**RE: Docket ID NRC-2018-0101**

**Florida Power and Light Application for Renewal Facility Operating  
License No. DPR-31 and DPR-41**

August 10, 2019

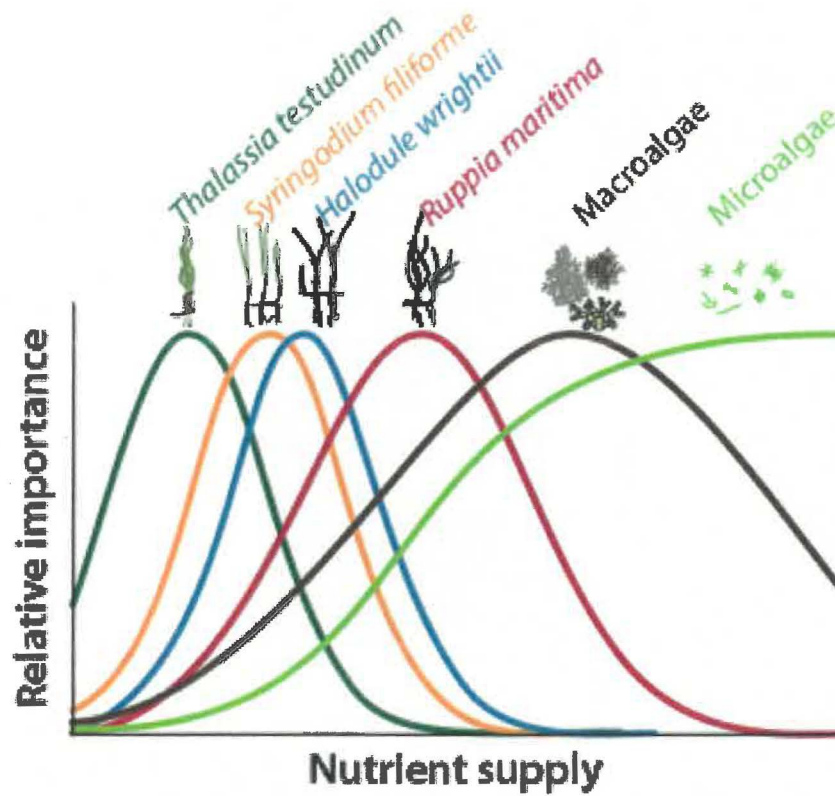
A model has been developed to illustrate how normally low-nutrient seagrass beds of south Florida will change as nutrient availability changes (Fourqurean and Rutten 2003, Figure 4). The model shows that seagrass beds composed of abundant turtle grass, the slowest-growing species, become lush with increased nutrient conditions. But, as nutrient supply continues to increase, the species composition gradually changes as faster-growing species replace the slower-growing ones. At the highest nutrient levels, seagrasses are replaced by seaweeds and microalgae. Loss of the seagrass community will result in a dramatic change in community structure and function. Animal species dependent on seagrass for food and shelter (e.g., speckled trout, redfish, bonefish and tarpon) are replaced by less desirable species (e.g., jellyfish). The model predicts that the

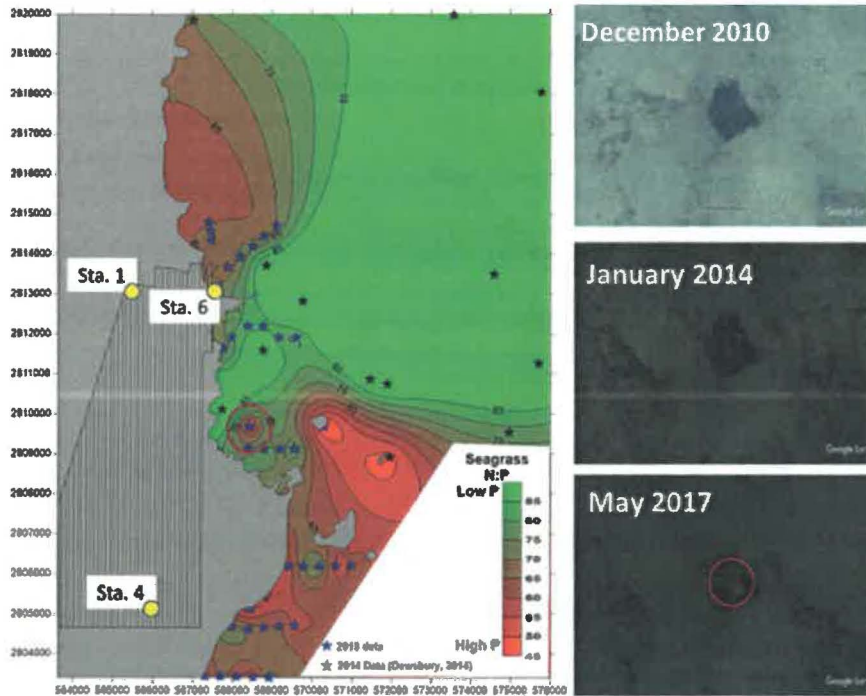
these plants form the basis of the essential fish habitat near Turkey Point, described on pages 3-112 and 3-113. Further, while the potential for impacts of cooling canal operations on emergent salt tolerant vegetation is recognized and assessed beginning on page 4-24, this general assessment only applies to saltmarsh vegetation. Herbaceous saltmarsh vegetation, however, is rare surrounding the Turkey Point CCS, while emergent woody vegetation (mangroves) and submerged herbaceous plants (seagrasses) are quite common. These special plant communities deserve a proper consideration because such consideration could change the conclusions of the GEIS. I believe we are recognizing environmental degradation of the seagrasses offshore of the CCS, as detailed above. Recent data (Miami Dade DERM) and modeling runs (done by E. J. Wexler) suggest that the input of heated water at the north end of the CCS is so great that water not only flows south into the CCS as designed, but also flows north, through the mangrove forest and into Biscayne Bay to the northeast of the CCS. There is evidence that this water is causing harm to the mangrove forests visible on Google Earth aerial images, and I believe that we can also see the footprint of this water in the enhanced P content of seagrasses along the shore (Figure 5).

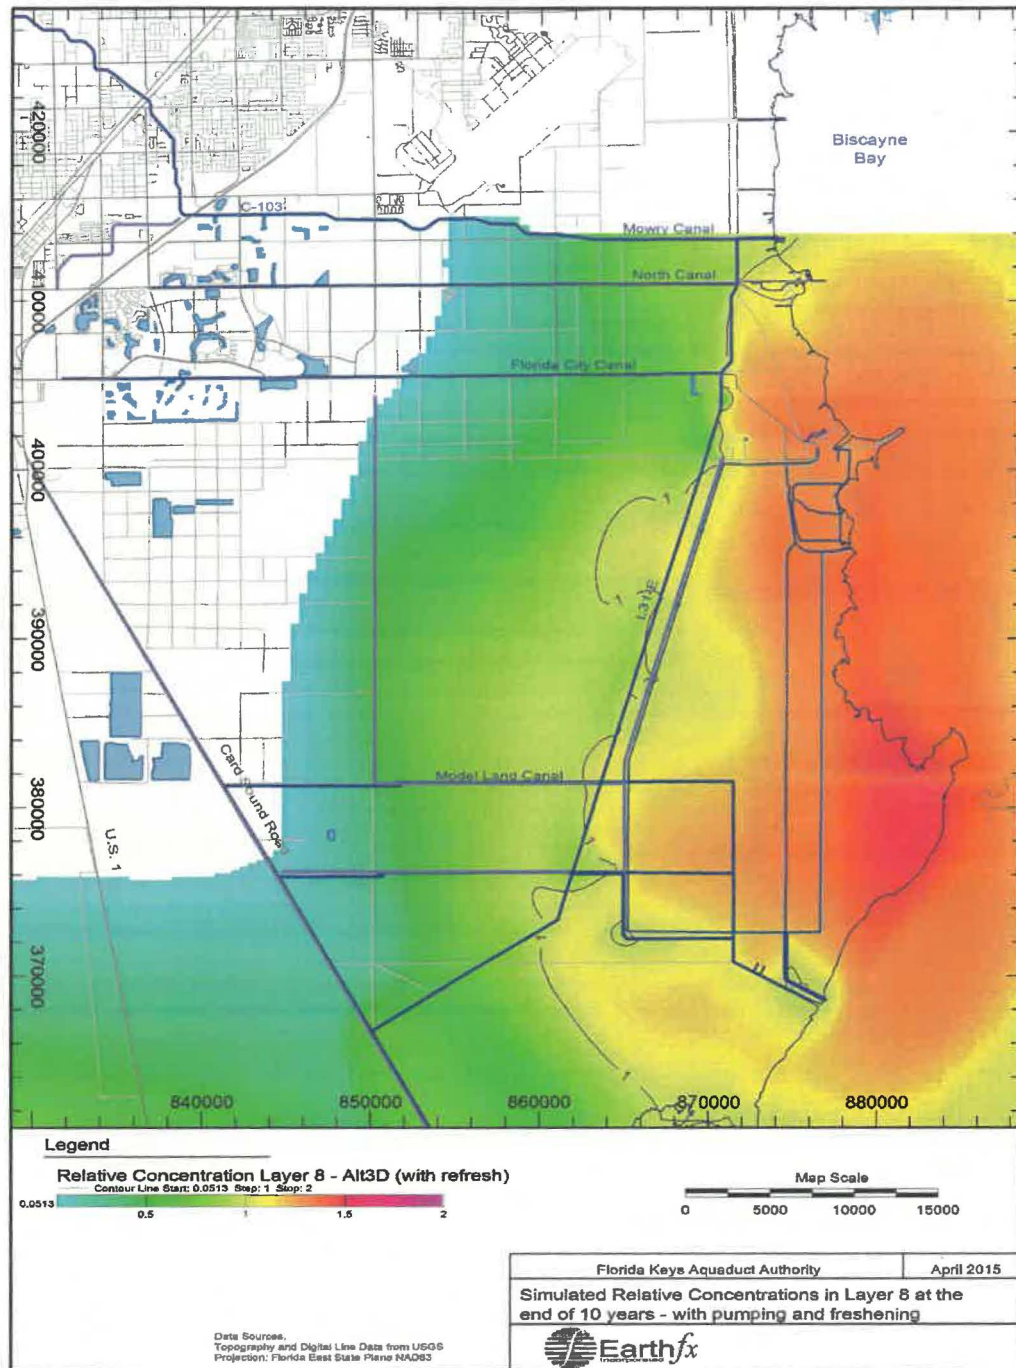
in Layer 8 (the “Lower High Flow zone” in the Tetra Tech (2016a) model) for the baseline conditions (pumping and freshening) are shown in Figure 1. The 1.0 relative salinity contour represents seawater salinity and is mostly near the CCS boundary. Results without freshening are shown in Figure 2 and show the 1.0 contour as much as 12,000 ft west of the CCS. These results indicate that, without being able to achieve freshening at the current time or in the future, the retraction of the hypersaline water is not likely to occur without the addition of more wells and increased pumped volumes. More analysis would be required to determine whether the additional withdrawals would have harmful effects and the additional water may, therefore, be unavailable. Thus despite the considerable lead time cited in the draft SEIS, groundwater remediation and improvement may not be possible prior to the subsequent period of extended operations without significant changes to the CCS operations and recovery well system.

Figure 4: Hydraulic conductivity values assumed for Layer 8 (Lower High Flow Zone) in the Tetra Tech (2017) model.

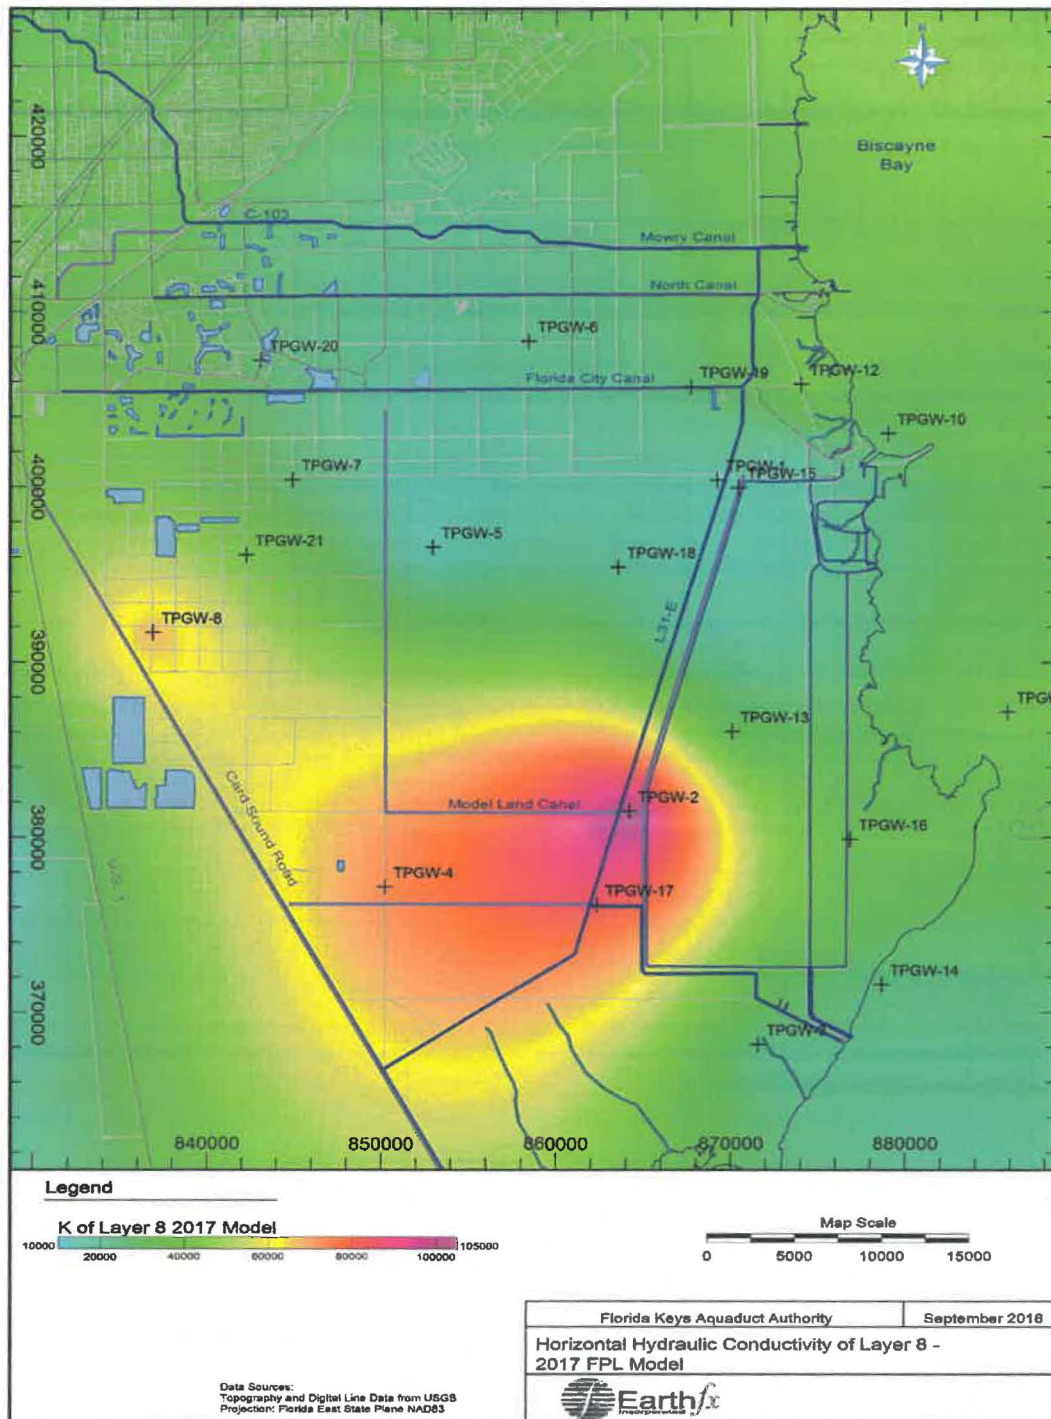
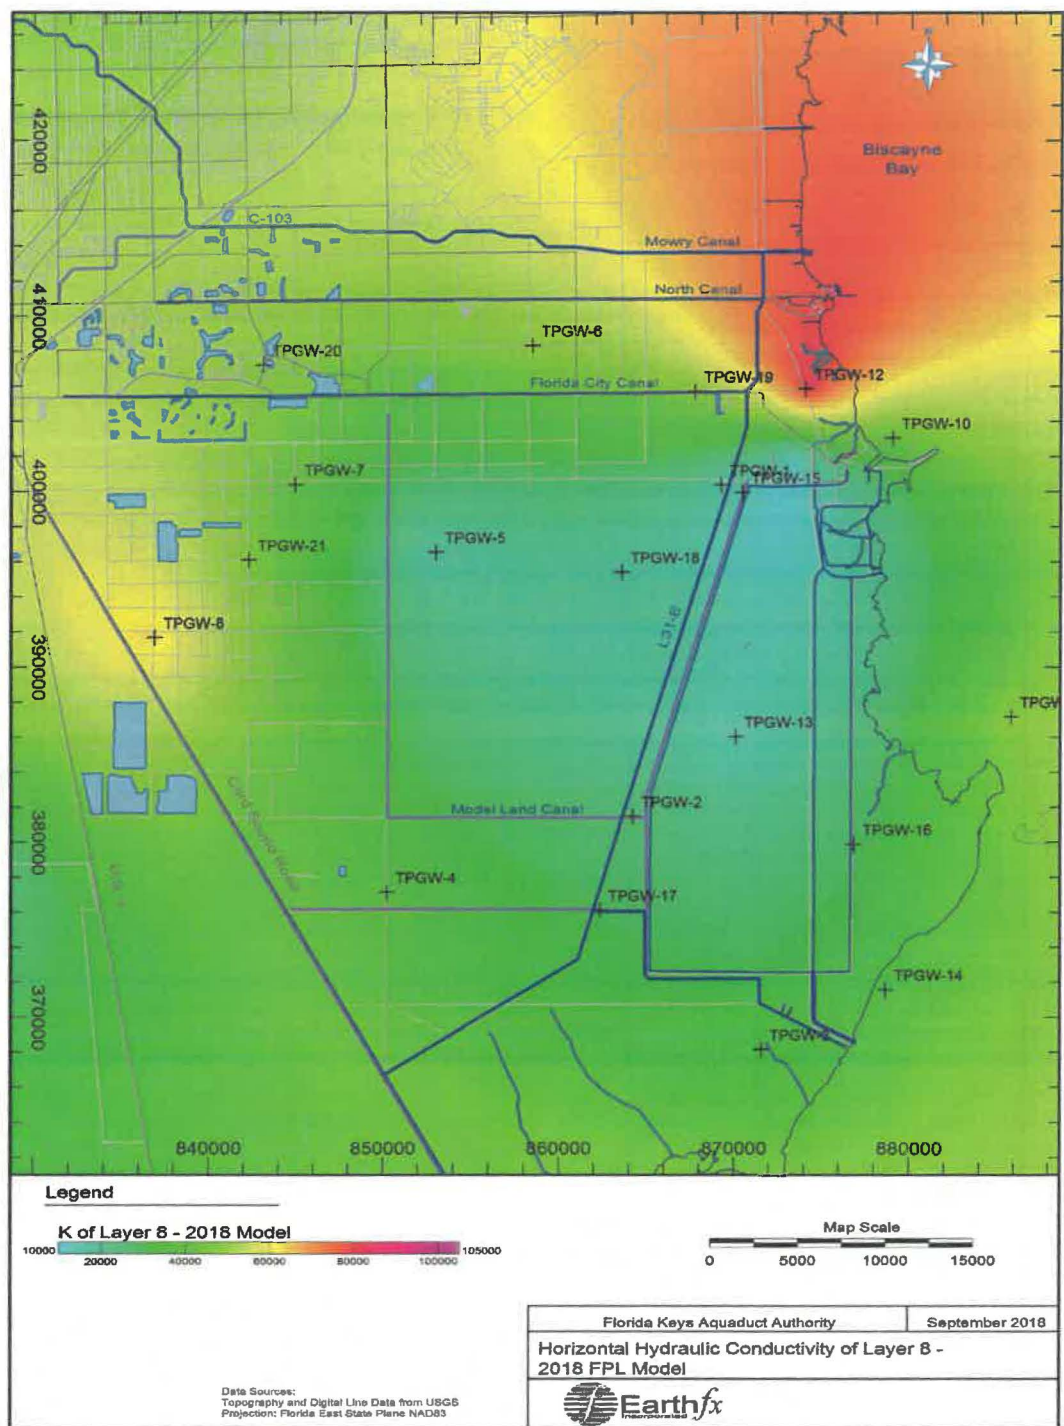
In particular, the horizontal hydraulic conductivity values have been changed from the previous (2017 update) model, with the newer values being generally higher. The spatial distribution of the high and low hydraulic conductivity values within Layer 8 (the most permeable layer) has been altered significantly. The zone of high hydraulic conductivity in the southwest part of the CCS (centered between TPGW-2 and TPGW-17) (shown in Figure 4) has been removed and relatively low values are assigned below the CCS and to the west in the 2018 model (Figure 5). This results in reduced westward migration of hypersaline water in the 2018 analyses. Layer 8 contributes the most to the transmissivity of the Fort Thompson Formation (the high permeability unit forming the principal part of the Biscayne Aquifer) and significant changes in transmissivity of this unit can be seen. Figure 6 shows the transmissivity of the Fort Thompson Formation (model Layers 3 to 11) in the Tetra Tech (2017) model (Figure 7), in thousands of ft<sup>2</sup>/d with a zone of high transmissivity within the southwestern part of the CCS. Figure 8 shows the transmissivity of the Fort Thompson Formation with the high transmissivity zone absent. Transmissivities west of Card Sound Road are generally higher in the 2018 model but still well below the observed values (e.g., Fish and Stewart, 1991 or Hughes and White, 2014).
